MEMORANDUM

Our Ref: ENV/DC/PP/2015/0900

Location: O. S Grid Ref: 332 506 16 To 18 Grosvenor Road, Wrexham.

Development: Erection of 34 Bed Care Home (Class C2) together with provision of 10 car parking spaces.

Turning Areas

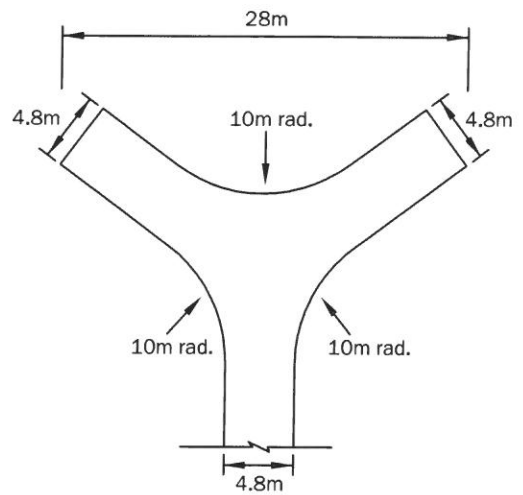
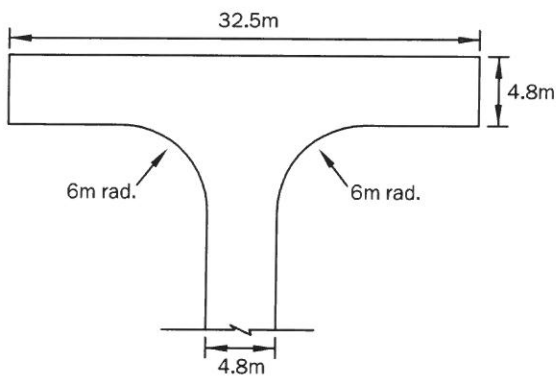
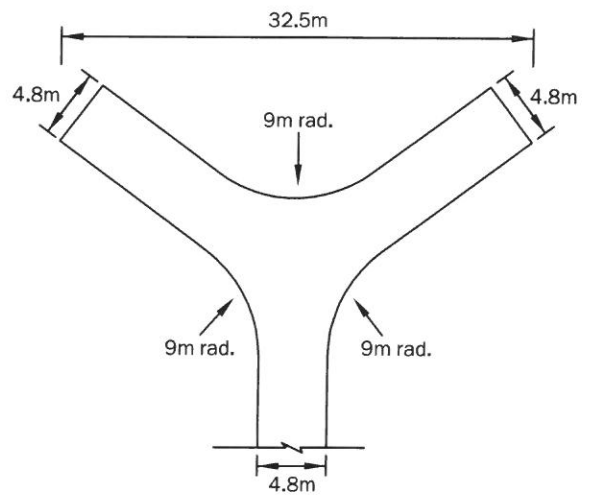
The submitted layout plan (Drg. No. 1477 / F03 / S02 / Rev C) has attempted to demonstrate the swept path movements of an 9m long refuse vehicle accessing the site for refuse collection. However, the WCBC Refuse Section normally use an 11.2m long vehicle.

The proposed turning head is of insufficient size to accommodate the turning movements of an 11.2m long refuse vehicle.

Could you please ask the applicant to provide a revised layout plan indicating a suitable sized turning head (see attached detail) including the swept path movements of an 11.2m long refuse vehicle entering / turning and exiting the site from both directions (in / out).

Turning areas are based on an 11.18m long, 2.55m wide refuse vehicle.
